CITY OF HOBART

City Planning Committee Meeting

**11. 52, 48-50, 46 NEW TOWN ROAD, 7A CLARE STREET AND ADJACENT ROAD RESERVE, NEW TOWN - DEMOLITION, NEW BUILDING FOR HOSPITAL SERVICES, BUSINESS AND PROFESSIONAL SERVICES, AND GENERAL RETAIL AND HIRE, SIGNAGE AND ASSOCIATED INFRASTRUCTURE WORKS
PLN-19-291 - FILE REF: F19/138302**

**APPLICATION UNDER HOBART INTERIM PLANNING SCHEME 2015**

SCREENING & ESD PRINCIPLES

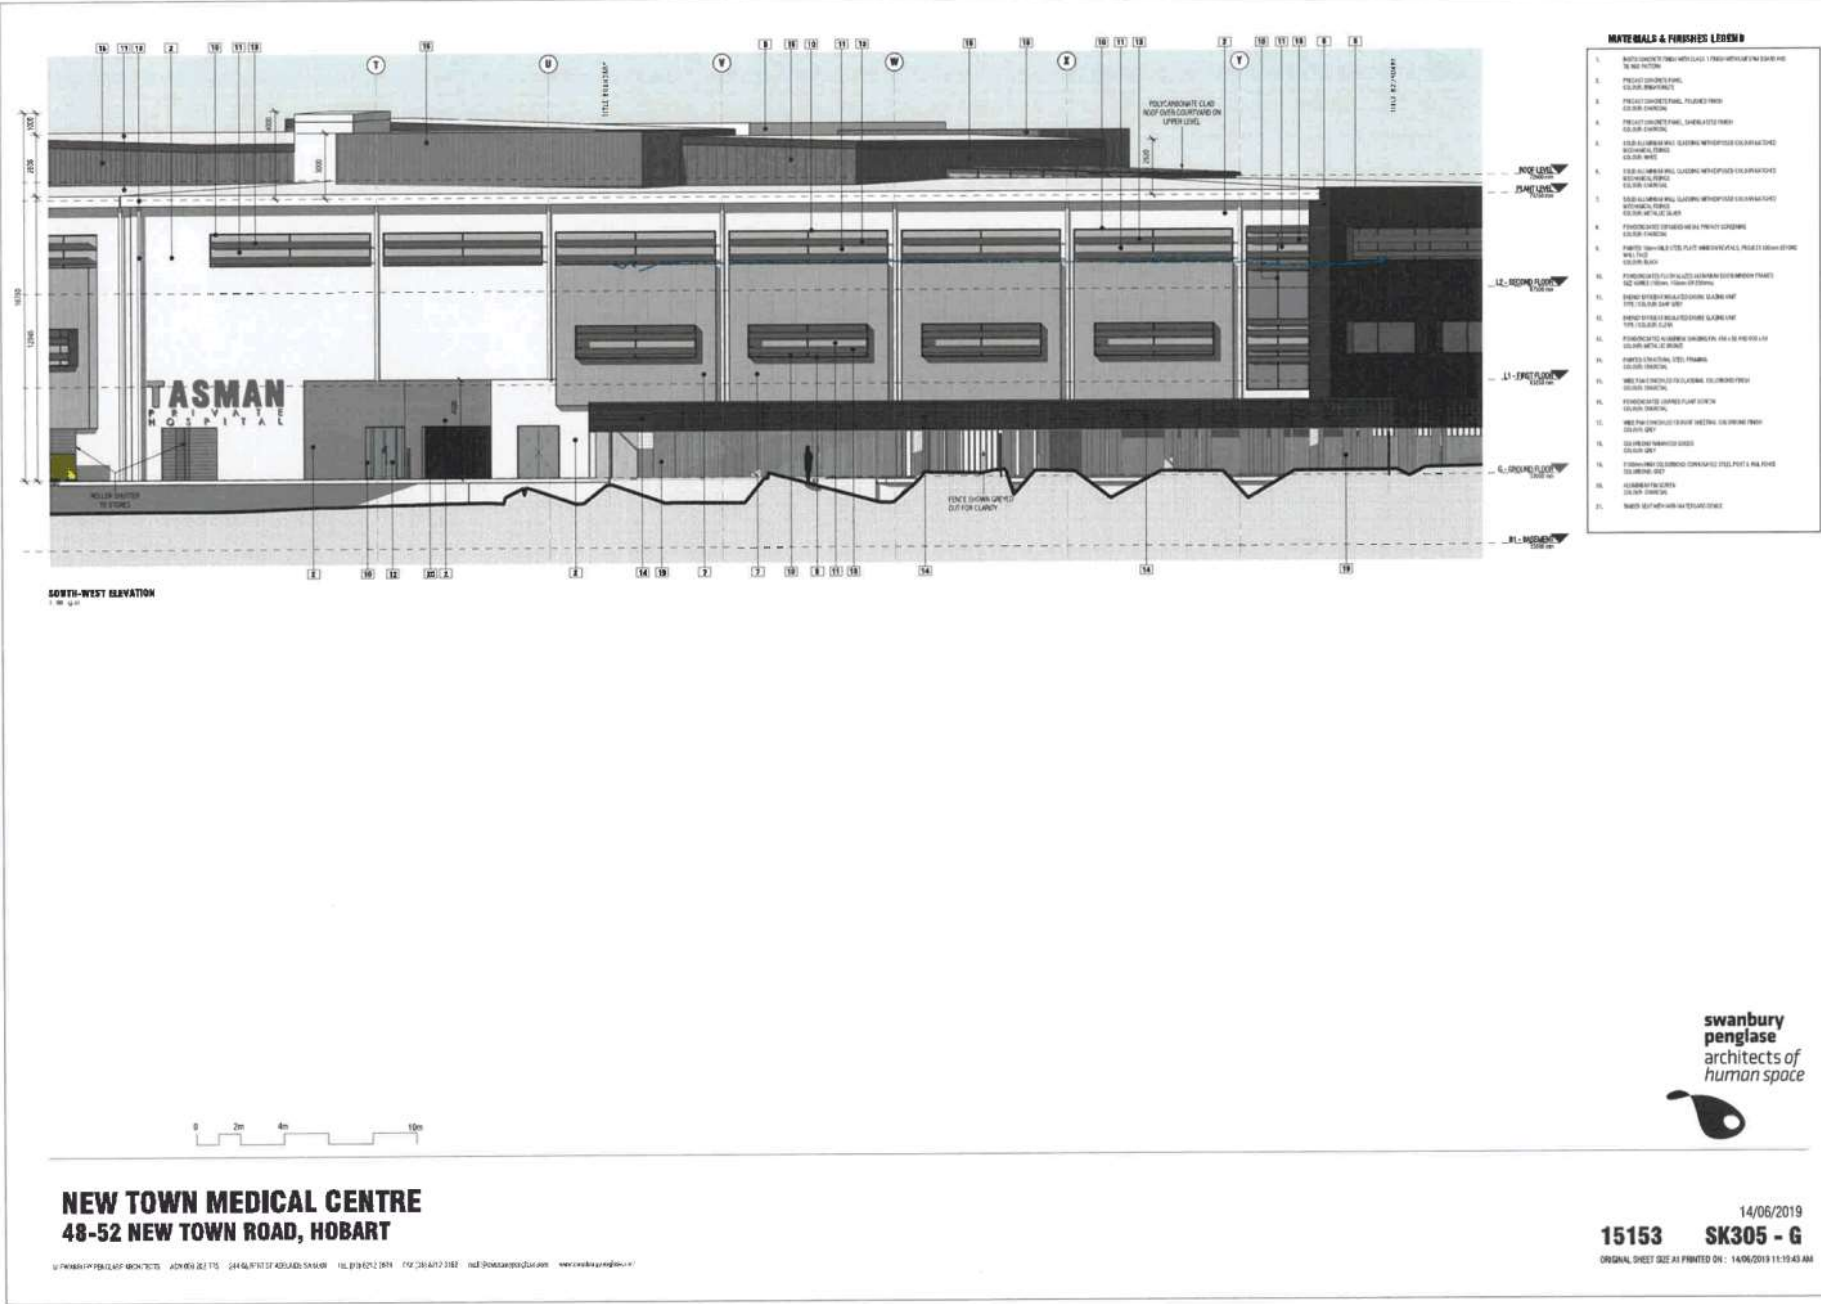
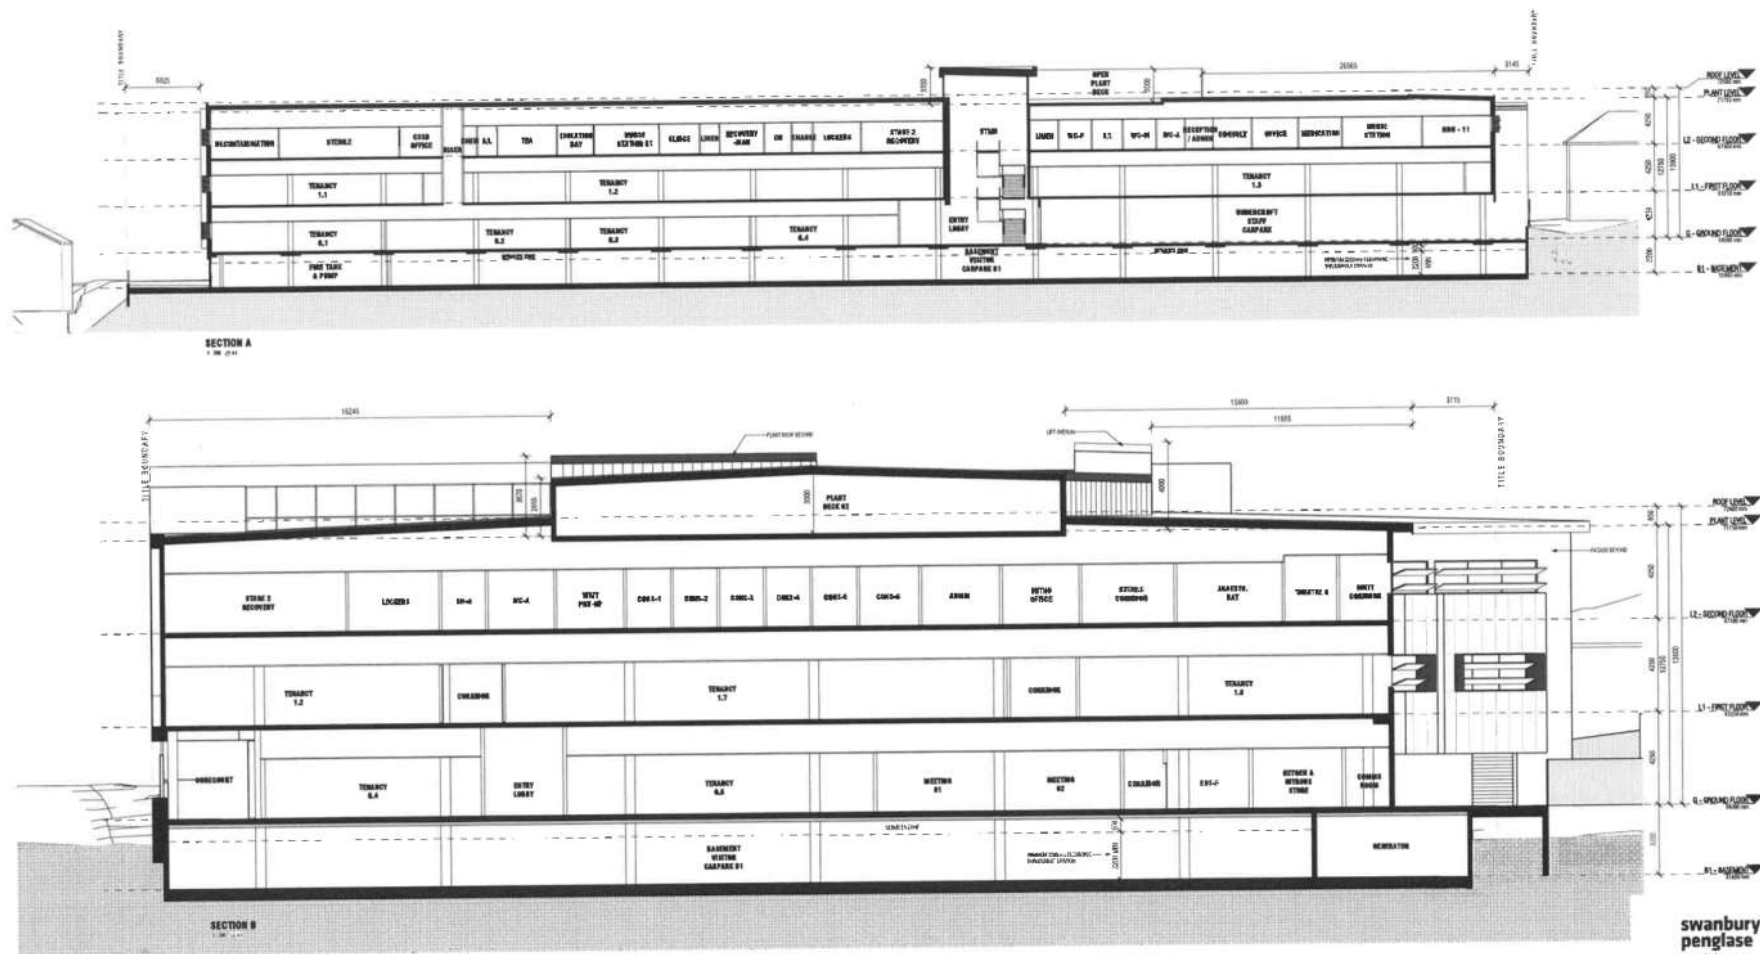
(b) The façade treatments incorporate louvres to windows, in particular on the western façade to prevent any overlooking of vacant properties which solves an existing problem with the current building on the site. (See sheet SK403-A in the accompanying architectural documentation). These louvres have been positioned to not only prevent any overlooking issues but to aid with solar control, allowing winter sun to passively warm the spaces and appropriately shading the summer sun, all while still providing framed views out to Mt Wellington.

(c) the accompanying architectural documentation, specifically drawing SK403-A demonstrates the setback distance between the proposal and the adjoining lots along Seymour and Clare Street. It also demonstrates that these setback distances significantly reduces the perceived overall visual bulk of the proposal.

Section diagrams on sheet SK403-A indicate that the only measure separating the backyards of 9-15 Seymour St from basement carpark noise is an "expanded mesh and vertical blade privacy screen". Described as "natural ventilation" on sheet SK202-R, this see-through sheet mesh will be a conduit for noise, exhaust fumes, particulates and odours to the homes and backyards adjoining residents 24-hours a day. The boundaries of these properties are all less than 3 metres from the vents. No landscaping treatments are proposed for this boundary that might attenuate these impacts. These are unreasonable and likely impacts on amenity under performance criterion 15.3.1 P1, and an extraordinary omission from the applicant's acoustic assessment that is symptomatic of a broader lack of care paid to impact issues elsewhere in the applicant's documents.
